HISTORIC JOPLIN PRESERVATION COMMISSION

Certificate of Appropriateness

Subject: Certificate of Appropriateness for Windows

Address: 218 S. Main Street

1 EAST ELEVATION - PROPOSED SIGNAGE

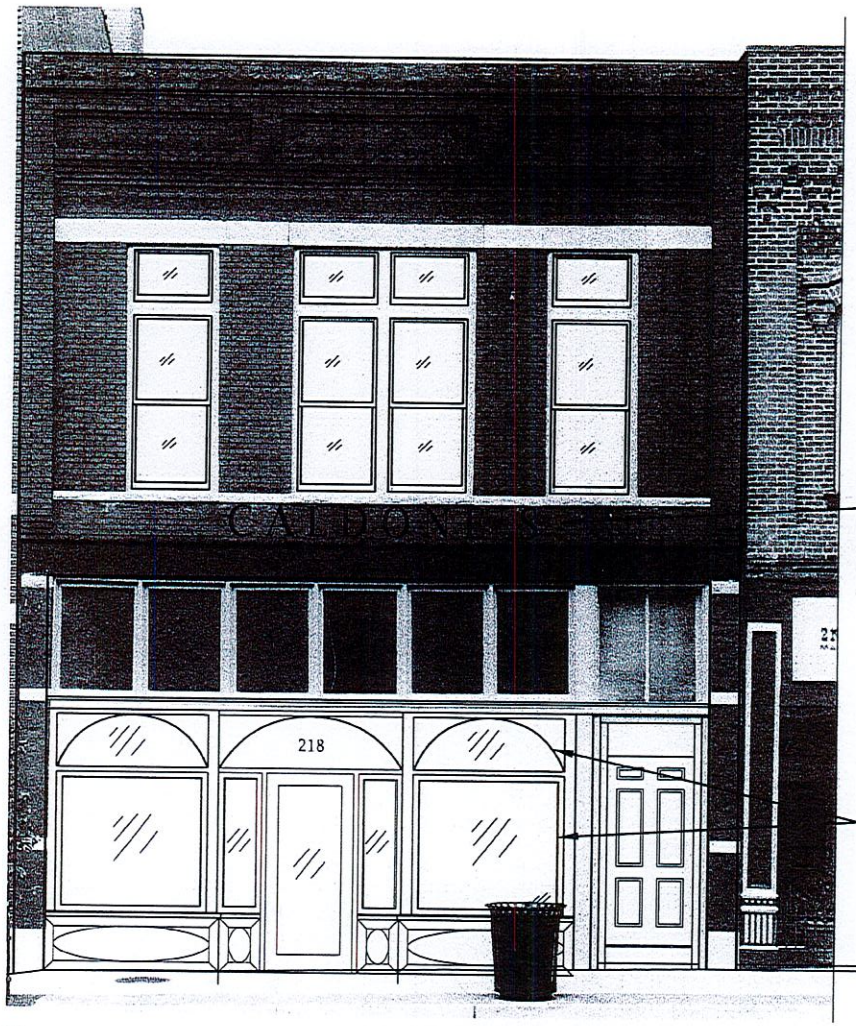
1. Replace cracked glazing units with new glazing to match original ribbed glazing.
2. Scrape and paint wood transom windows with on e coat of primer and two coats of paint. Replace deteriorated wood sections as required, in kind.
   Applicant proposed to tint the windows over the transom and the display windows opposed to using the glazed windows: Does not comply – Tinted Glass is against the Design Review Standards

1. Prime and paint existing door to match new storefront.
   The north door is solid door: Does not comply – Solid Doors are not allowable on front facades

1. The architect show no signage in her conceptual drawing
   Decrease the size of the storefront bottom windows and doors to include a sign that will be 18' long and 12" inches high. Proposed lettering is san serif. Does Not comply – The overall sign area (60" as letters stretched exceeds the recommended lettering

1. Remove false brick veneer from recessed entrance. Install new vertical beadboard, paint to match storefront. Applicant proposed to follow the architects suggestion and paint the vertical beadboard Sherwin Williams Tree Top Green – Complies with DRS Standards

Because of Mr. Bennet's time constraints, he decided to comply with the DRS Standards by adopting the conceptual plan as submitted by the architect. Susan Richard Johnson plan does comply with all the DRS standards.

Staff recommends the Historic Preservation Commission to approve the Certificate of Appropriateness for the conceptual plans submitted by Susan Richards Johnson for 218 S. Main
